Response to 12/02/77 set of questions
concerning Applicant's overpressure
protection system submittal of 10/31/77...
w/att supporting graphs....

RE: H. B. ROBINSON STEAM ELECTRIC PLANT, UNIT NO. 2
DOCKET NO. 50-261
LICENSE NO. DPR-23
RESPONSE TO OVERPRESSURE PROTECTION SYSTEM QUESTIONS

FIGURE 13. H.B. ROBINSON UNIT NO. 2 REACTOR COOLANT COOLDOWN LIMITATIONS APPLICABLE FROM 20 UP TO 32 EFFECTIVE FULL POWER YEARS

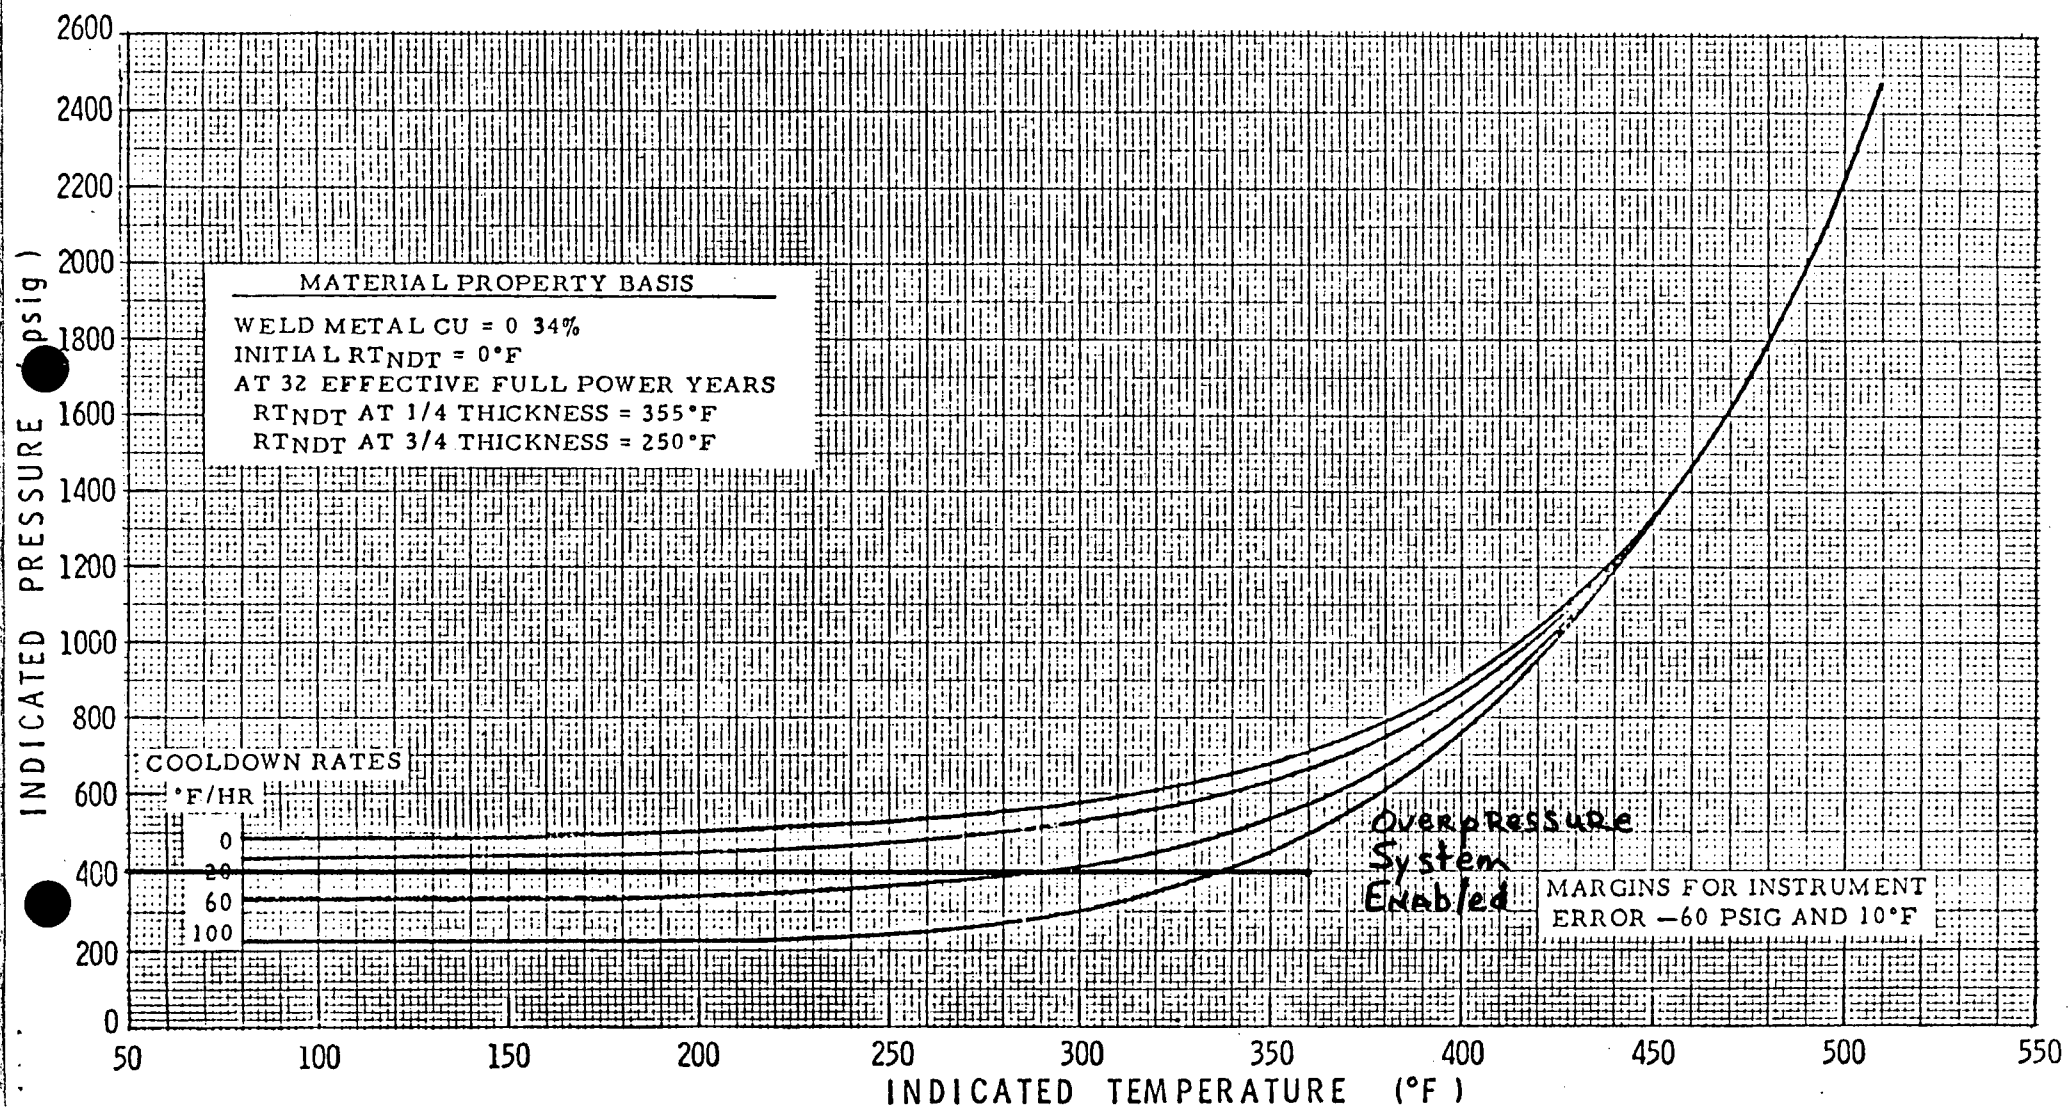
1. What is the range of PORV setpoints? Show a curve of setpoints (with RCS temperature) on Appendix G curve.

While the H. B. Robinson system will utilize function generators the nature of the end of life Appendix G curve has caused CP&L to choose a constant setpoint of 400 psig when the overpressure protection system is operable. The end of life (32 EFPY) and 20 Effective Full Power Year (EFPY) curves with the setpoint shown are attached.
